ADDENDUM NO. 1

August 26, 2024

**LATHROP GATEWAY ARCHES
CIP GG 24-23**

This addendum amends the Contract Drawings and Specifications for this project as follows:

COVER SHEET

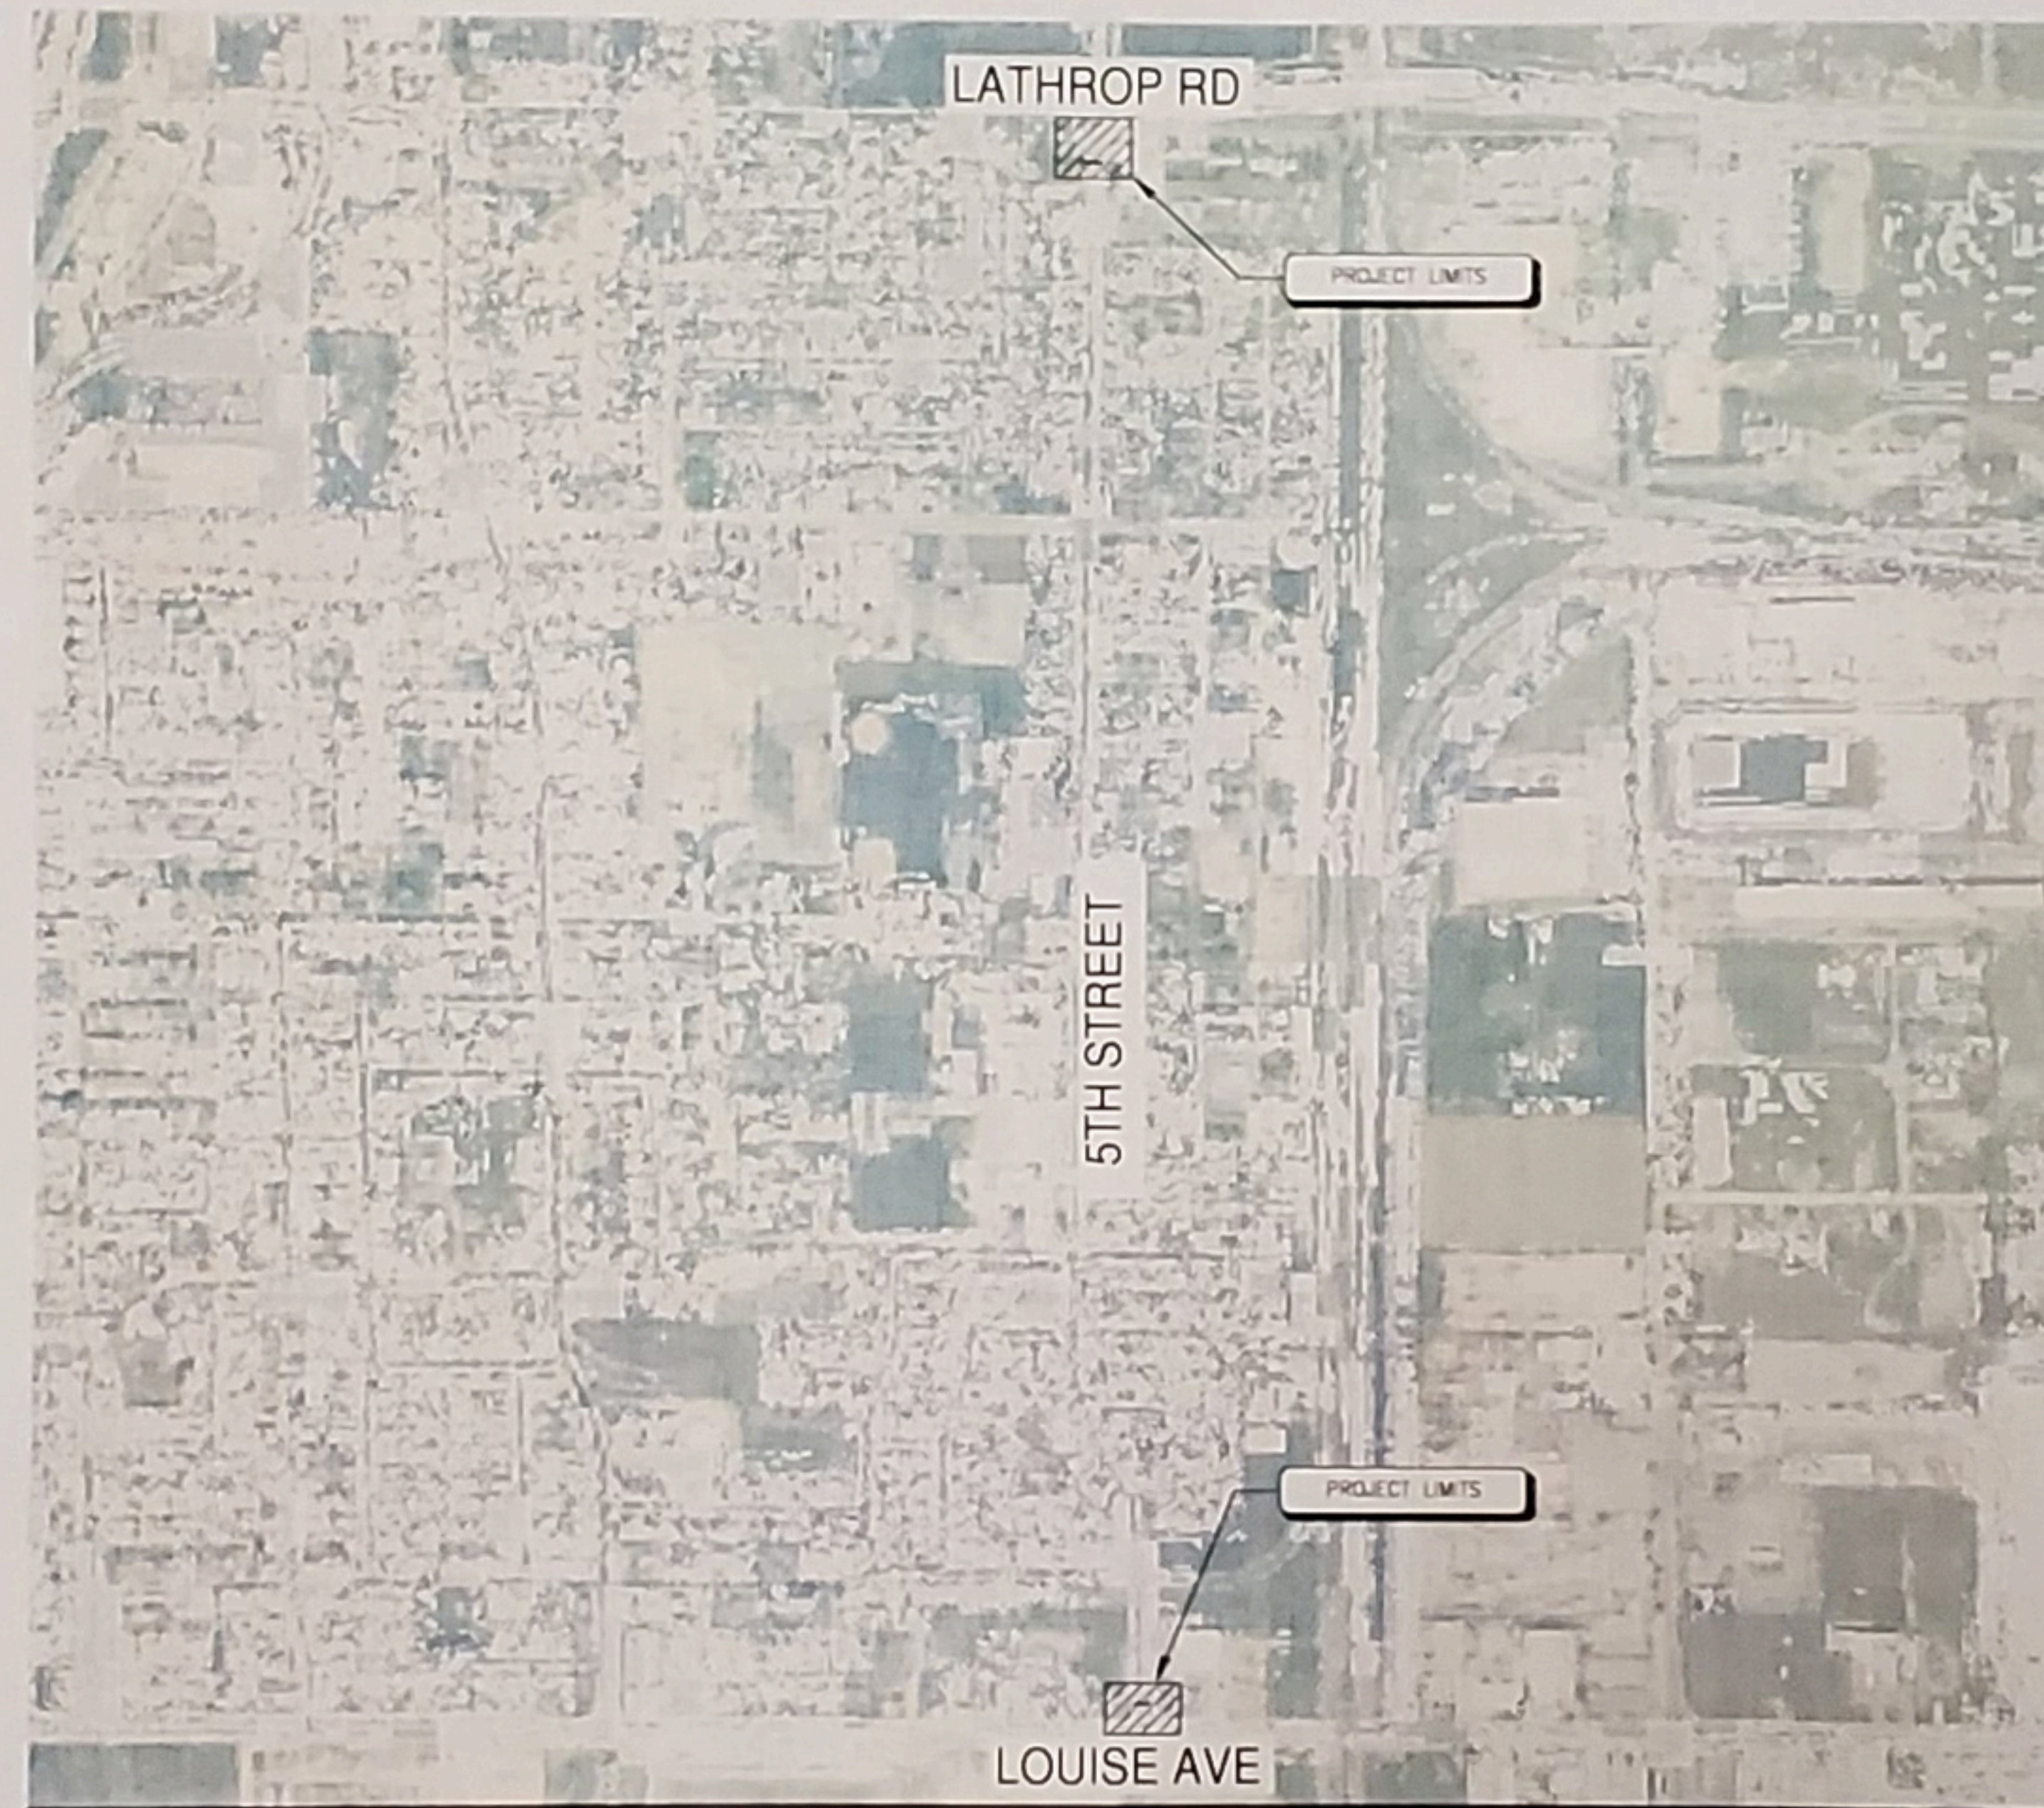
1. Revise Cover Sheet to include City of Lathrop signatures
2. Revise sheet L2.0 to remove "Drip and Low Flow Emitter Notes"

CITY OF LATHROP DEPARTMENT OF PUBLIC WORKS	
APPROVED BY: <u>N/A</u> ASSISTANT CITY MANAGER	DATE: _____
CITY OF LATHROP CONSTRUCTION MANAGEMENT DEPARTMENT	
APPROVED BY: <u>N/A</u> SENIOR CONSTRUCTION MANAGER	DATE: _____
CITY OF LATHROP ENGINEERING	
APPROVED BY: <u>[Signature]</u> CITY ENGINEER	DATE: <u>8/26/2024</u> RCE NO: <u>092823</u> EXP DATE: <u>12/31/25</u>
